Agenda
Village of Glen Ellyn
Plan Commission Meeting
Thursday, May 4, 2023
7:00 PM
Glen Ellyn Civic Center, Galligan Board Room

STAFF REPORT

SUBJECT: 490 Kenilworth Avenue - Frank Johnson Center; Glen Ellyn Park District-Special Use Permit and Zoning Variation

REQUEST: Approval of a Special Use Permit associated with construction of a new maintenance facility, associated outdoor storage, and site development. In order to accommodate the project, the petitioner is specifically requesting approval of the following:

1/4" = 1'-0"

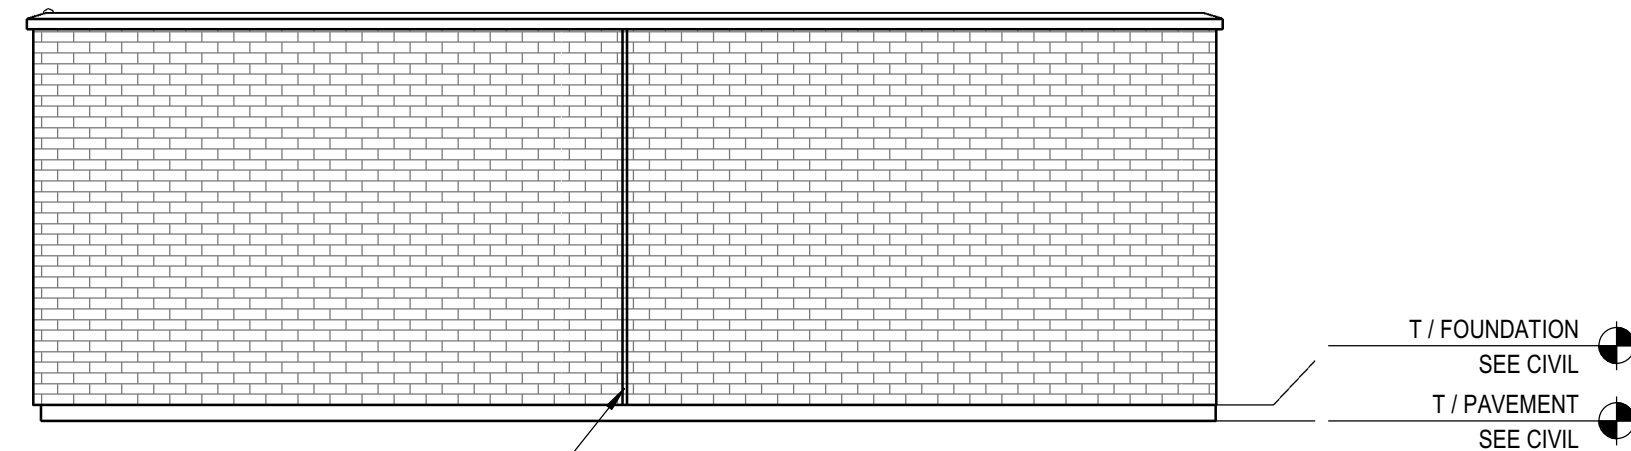
4. Trash Enclosure. A masonry trash enclosure is provided. The enclosure meets the Municipal Code for height as it is 8' with two metal gates and is open on the top.
